UNITED STATES PATENT AND TRADEMARK OFFICE

APPLICATION NO.	FILING DATE	FIRST NAMED INVENTOR	ATTORNEY DOCKET NO.	CONFIRMATION NO.
10/797,149	03/11/2004	Takashi Ohama	118736	4313
25944 7590 08/21/2007 OLIFF & BERRIDGE, PLC P.O. BOX 19928 ALEXANDRIA, VA 22320			EXAMINER MCCULLOUGH, MICHAEL C	
			ART UNIT 3653	PAPER NUMBER
			MAIL DATE 08/21/2007	DELIVERY MODE PAPER

Office Action Summary

DETAILED ACTION

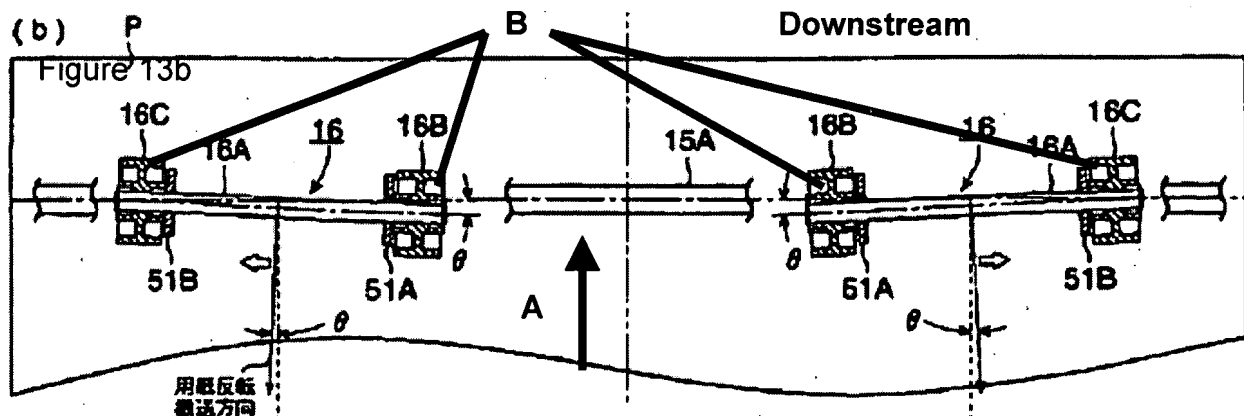
In claims 15 and 18 lines 2-4 and 9-12, it is indefinite what is meant "a centermost end of a second drive shaft segment **one of more upstream and more downstream** in the recording medium feed direction than the first drive shaft and the other end of such second drive shaft segment **one of more downstream and more upstream** than the first drive shaft". How is a centermost end more upstream and more downstream than the first drive shaft? How is the other end more downstream and more upstream? What is "centermost" referring to? How can the centermost end more upstream and more downstream and the other end more downstream and more upstream, wouldn't one end have to be more upstream than the other end of the slanted shaft?

FIG. 1

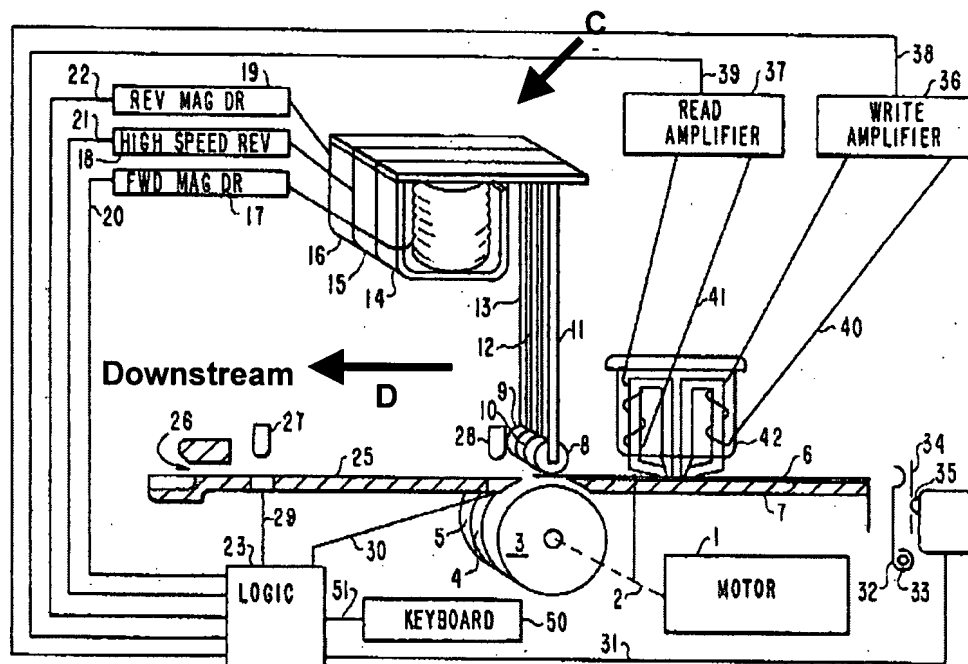
6. Claims 1, 3, 6- 8, and 10 are rejected under 35 U.S.C. 103(a) as being unpatentable over Fowler et al. (US 3,66,262) in view of Sako et al. (US 6,073,927). Fowler et al. discloses a sheet feeder in an image reading apparatus comprising an image reading part (37), a drive roller unit (3, 4, 5) with an axis (2) perpendicular to the sheet feed direction (see Figure 1 arrow D, below) that includes driven rollers and is downstream from the image reading part, a driven roller unit (see Figure 1 element C, below) with the same amount of driven rollers (8, 9, 10) as drive rollers arranged symmetrically with respect to a center line (see Figure 3a line E, below) with axes on a slant (8a and 10a) such that the end portion of each axis far from the center of the width is upstream and the close to the center is downstream, an urging member that urges segments of the driven roller unit independently (see column 3 lines 20-27), and a straight conveying path (7 and 25). Fowler et al. does not disclose the drive roller has a coefficient of friction greater than a coefficient of friction of the driven rollers and a conveying pair upstream from an imaging part and a curved conveying path. However, Sako et al. discloses a similar device that includes the drive roller has a coefficient of friction greater than a coefficient of friction of the driven rollers (see column 6 lines 13-20), a conveying roller pair (22 and 21), and a curved conveying path (23) for the purpose of easily sliding against each other (see column 6 lines 13-20), separating a sheet (see column 4 lines 56-63), and guiding a sheet. It would have been obvious for a person of ordinary skill in the art at the time of the applicant's invention to modify Fowler et al. by utilizing drive rollers with a coefficient of friction greater than a coefficient of friction of driven rollers, a conveying pair, and a curved conveying path as
